FIELD SERVICE BULLETIN

MODEL E-200D

SUBJECT: AUDIO MODULATION

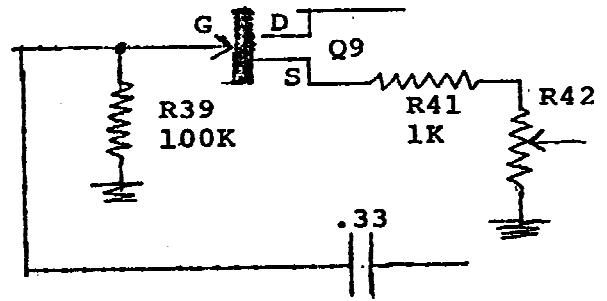
PROBLEM: DISTORTION OR TEMPERATURE SENSITIVE AUDIO MODULATION

REPLACE TRANSISTOR Q9, 176-020-9-001 WITH F.E.T., 182-011-9-001 AND REMOVE RESISTOR R38 (330K ohm) AS SHOWN BELOW. (NOTE DIFFERENCE IN F.E.T. WIRING)

FET: 2N5458

TRANSISTOR  
WIRING

F.E.T.  
WIRING

After modification adjust R42 for a reading of 1 volt RMS at "Ext. Mod." jacks with "Modulation" switch in 400Hz out position. (Approximately 3V P-P if adjusted with an oscilloscope).
